Service Bulletin

Bulletin No.: 17-NA-097

Subject: Side Blind Zone is Not Working Correctly and/or Incorrect Side Mirror Notification

Brand:	Model:	Model Year:		VIN:		Engine:	Transmission:
		from	to	from	to		
Chevrolet	Bolt EV	2017	2017	SOP	June 1, 2017		
Opel / Vauxhall	Ampera-e

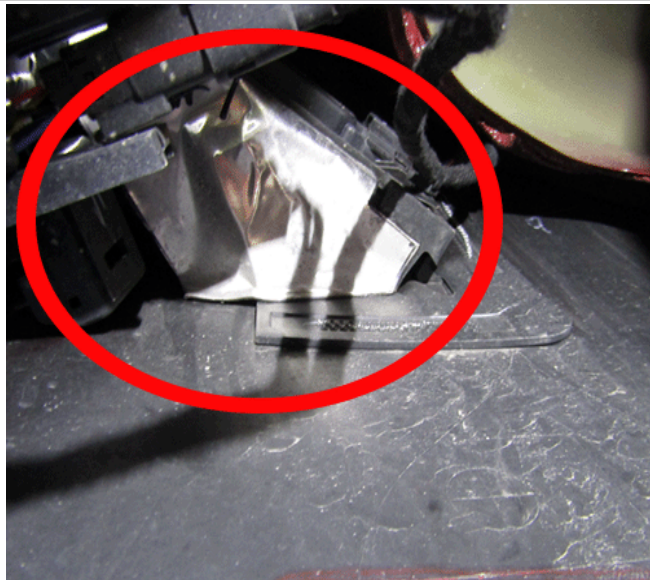
Involved Region or Country	North America, Europe, South Korea, Middle East
Additional Options (RPOs)	Equipped with Side Active Safety Obstacle Detection Enhanced (RPO UKC)
Condition	<p>Some customers may comment when driving, the side mirror indicates there is a vehicle present when there actually is not.</p> <p>The technician may find one or more of the following conditions:</p> <ul style="list-style-type: none"> • Wiring harness to the sensors may not be properly connected or routed. • Butyl tape not covering the sensor bracket completely. • Butyl tape missing completely.
Cause	<p>If the side blind zone has been found not working properly, inspect one or more of the following areas:</p> <ul style="list-style-type: none"> • Butyl tape application at the sensor brackets. • Sensor harness electrical connection and routing. • Poor grounding at the G401 and/or G404 body ground.
Correction 1	<div style="text-align: right;">  </div> <p style="text-align: right;">4749843</p> <p>Inspect the wiring harness electrical connectors for proper connections and routing.</p>

4749759

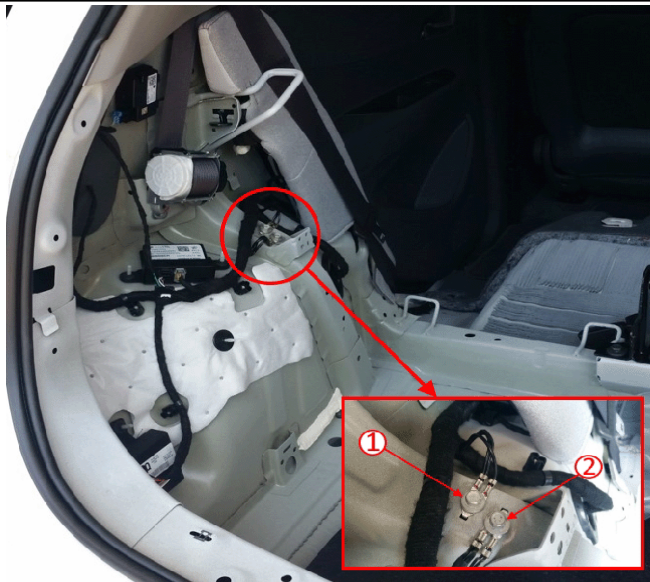
Important: The opening must be completely covered with the butyl tape to avoid allowing unwanted radar reflection to be detected and triggering the false alerts. Install a new single piece of aluminum butyl tape on the bottom of the object sensing alert module brackets so the opening is completely covered by the tape.

4847139

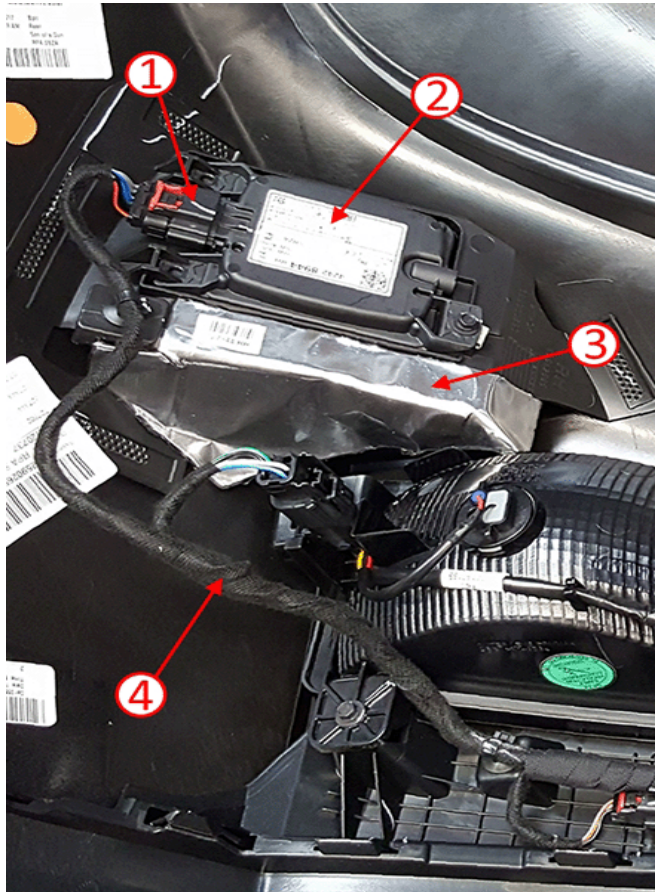
Remove the G401 (2) and G404 (1) grounds. Clean and remove paint from contact points.
